APPLICATION NO.	FILING DATE	FIRST NAMED INVENTOR	ATTORNEY DOCKET NO.	CONFIRMATION NO.
10/031,218	05/07/2002	Marcus Filshie	02597	2627

Office Action Summary

DETAILED ACTION

Fig. 1

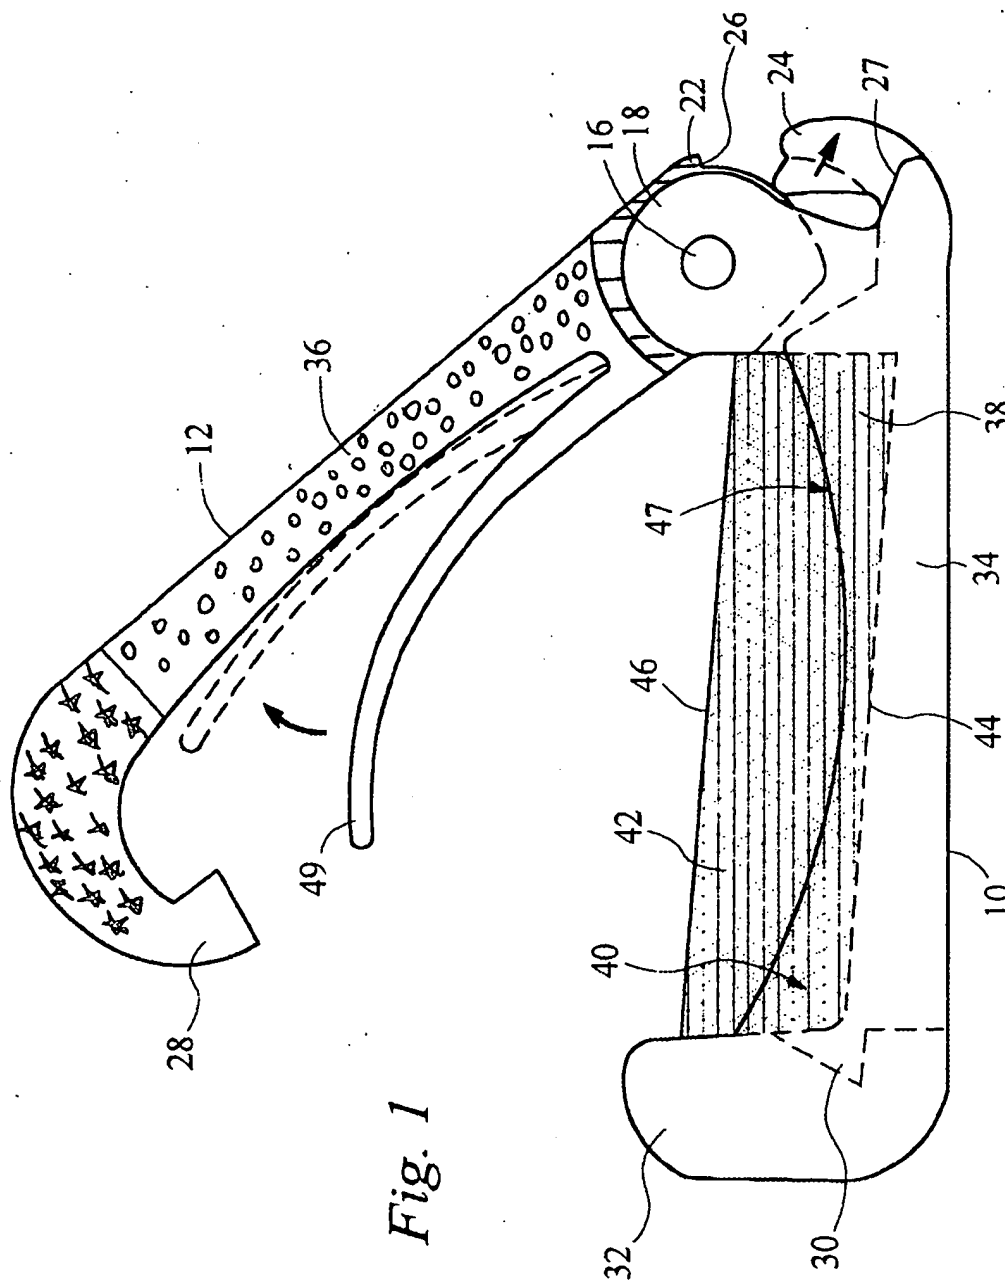
2. Regarding Claim 2, Casey '255 discloses generally straight section (28) [Fig. 1].
3. Regarding Claim 4, straight section 28 extends distally from latching means 30.
4. Regarding Claims 5 and 6, the first and second arcuate shaped portions (denoted respectively by circles and stars in Attachment #1) has the same width (laterally) along its length.
5. Claims 1-3 are rejected under 35 U.S.C. 103(a) as being unpatentable over U.S. Patent No. 4,418,694 to Beroff et al. in view of U.S. Patent No. 6,206,896 B1 to Howell et al. Beroff discloses a surgical clip for clamping blood vessels having upper jaw 11, lower jaw 12, and hinge 13. The upper jaw has straight section 23 and an arcuate shaped section including first portion 22 (larger radius of curvature) and second portion 10 (smaller radius of curvature). Beroff's clip is not lined with silicone rubber.

That is, the differentiation Applicant is making is that the *radius of curvature* of the outer surface of the *first* arcuate section is larger than the radius of curvature of the *second* arcuate section. U.S. Patent No. 5,846,255 to Casey in view of U.S. Patent No. 4,822,348 to Casey meets this limitation. Although Applicant is correct in pointing out that the outer surface of member 36 is flat, the member 36 taken as a whole can accurately be described as arcuate shaped since its lower surface is curved, and the average curvature of the whole beam (i.e. the center line) is slightly curved.

Regardless, the outer surface of member 12 is not curved, but is a flat surface. Examiner contends, however, that *the radius of curvature of a straight line is infinite*, as

evidenced by "The History of Curvature, page 4 of 7, last paragraph, lines 3 and 4. Therefore, the radius of curvature of the starred section [see Attachment #1 attached hereto] is less than the radius of curvature of the section having circles drawn therein, because the radius of curvature of the outer surface of the section having circles drawn therein is *infinite*.
